NUMBER: B391R1145-0

SERVICE BULLETIN

Ride: FALLING STAR

Subject: Gearbox Inspection

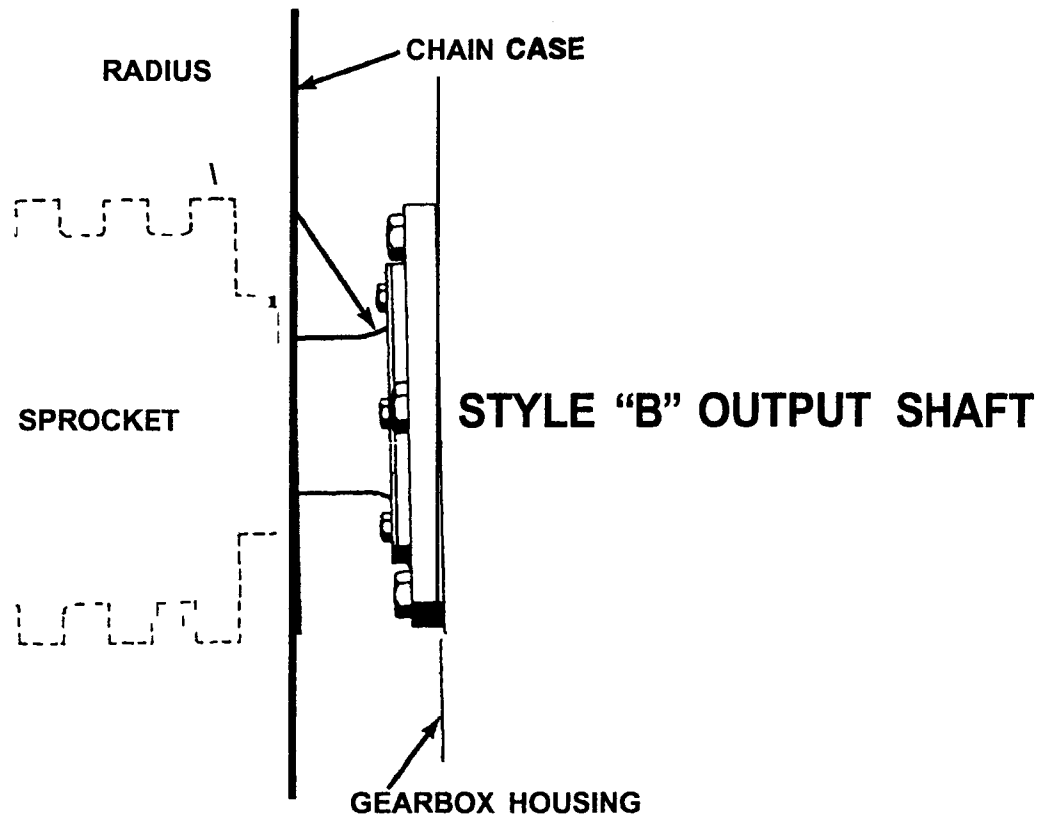
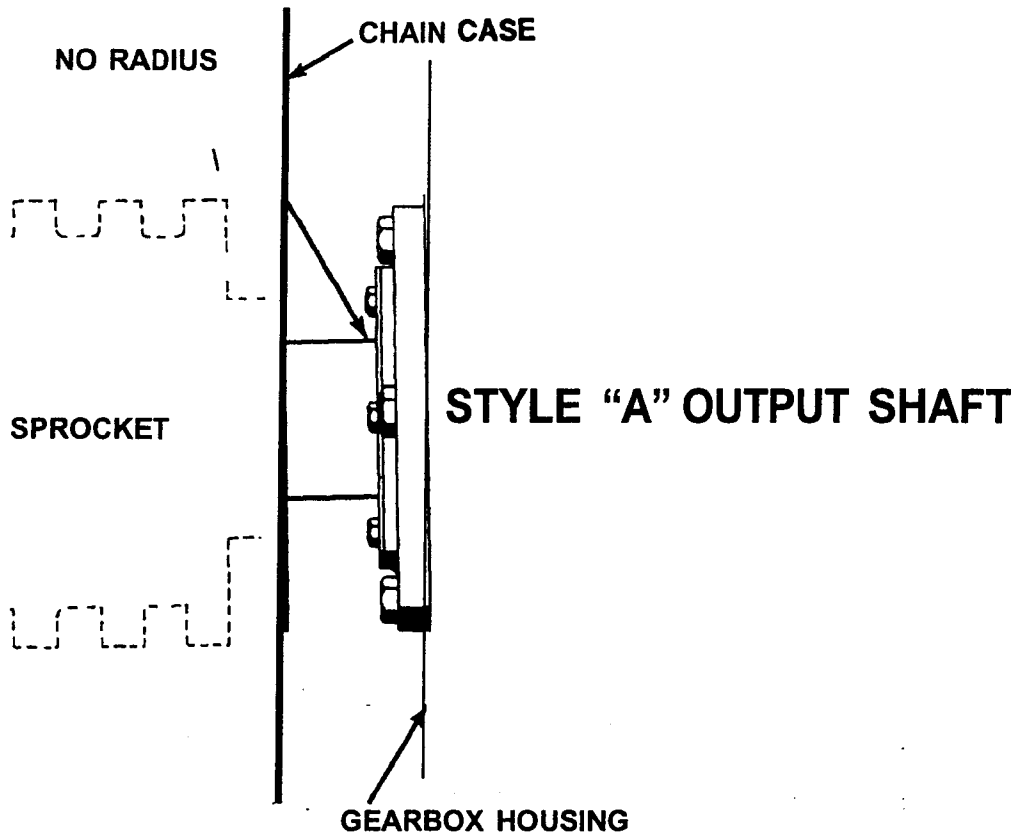
1. Remove inspection plate from top of gearbox.
2. Slowly rotate gears while visually inspecting gears for pitting, broken teeth, and/or uneven wear.
3. Identify large output shaft style, see illustration.

**INSPECT THIS
SHAFT TO IDENTIFY
STYLE "A" OR STYLE "B"**

**REMOVE THIS COVER
TO INSPECT GEARS**
